1.0 SUMMARY OF APPLICATION DETAILS

Ref: 20/01172/FUL
 Location: 93 Blenheim Park Road, South Croydon, CR2 6BL.
 Ward: South Croydon
 Description: Erection of a part single, part two storey side extension, rear extension, alterations and extensions to the roof and conversion of the property into 4 self-contained units.

2.0 RECOMMENDATION

Fig 3: Proposed site plan showing proposal in relation to neighbouring properties

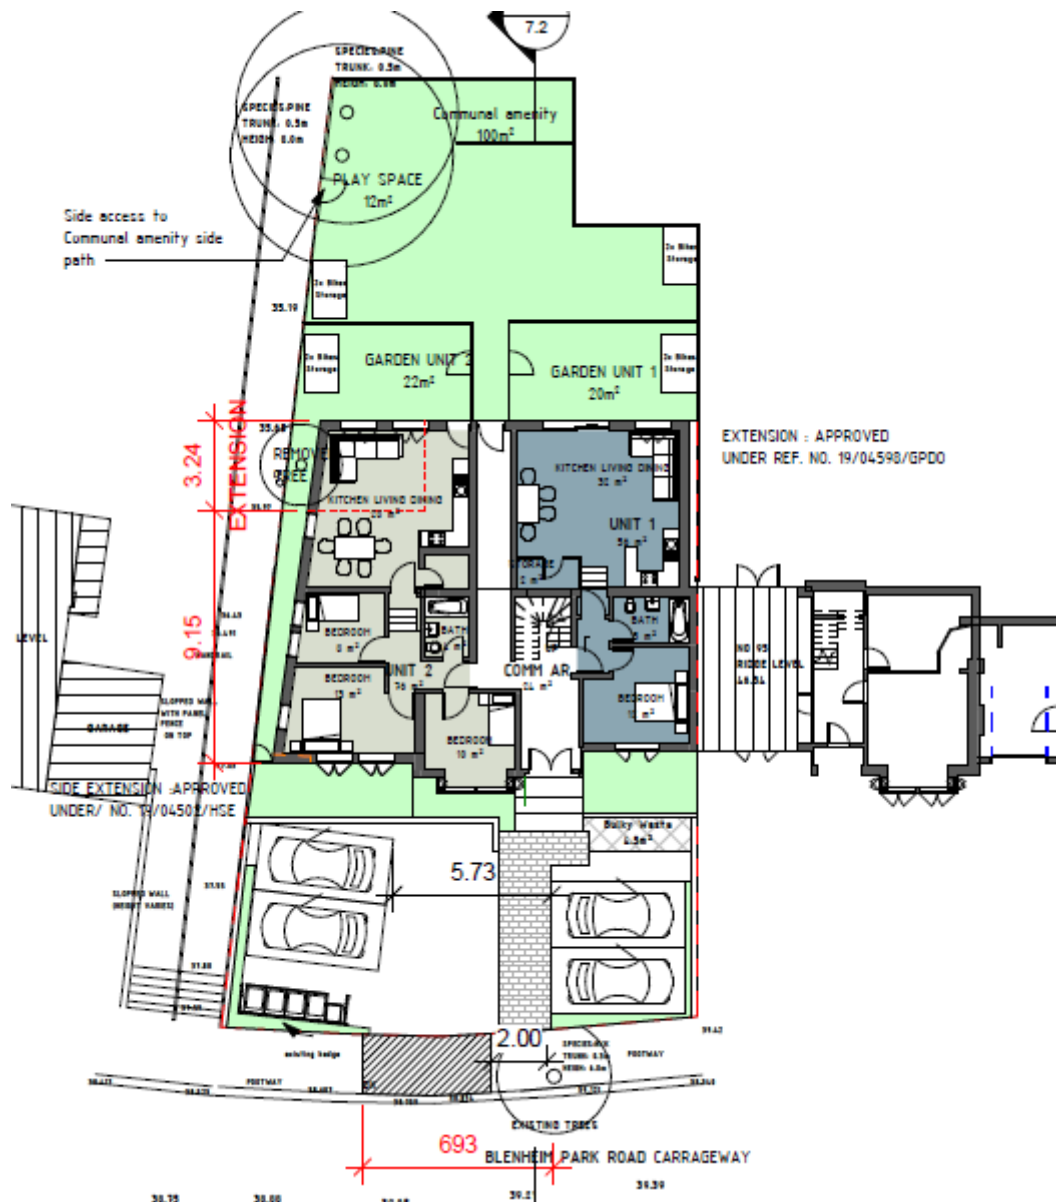
8.13 Policy DM10.2 seeks to create well defined and designed public and private spaces and advises that forecourt parking should only be allowed where it does not cause undue harm to the character or setting of the building and is large enough to accommodate parking with sufficient screening to prevent vehicles encroaching on the public highway. The frontage of the site would have an area of hardstanding surrounded by soft landscaping. Given the overall scale of the development and number of forecourt hardstanding areas in the vicinity, the extent of hardstanding would not be excessive. The site would offer sufficient opportunities for soft landscaping to the front, rear and around the site boundary.

8.14 The application site is a substantial plot within an established residential area. The scale and massing of the new buildings would generally be in keeping with the overall scale of development found in the immediate area whilst sensitively

intensifying it and the layout of the development would respect the streets' pattern and rhythm.
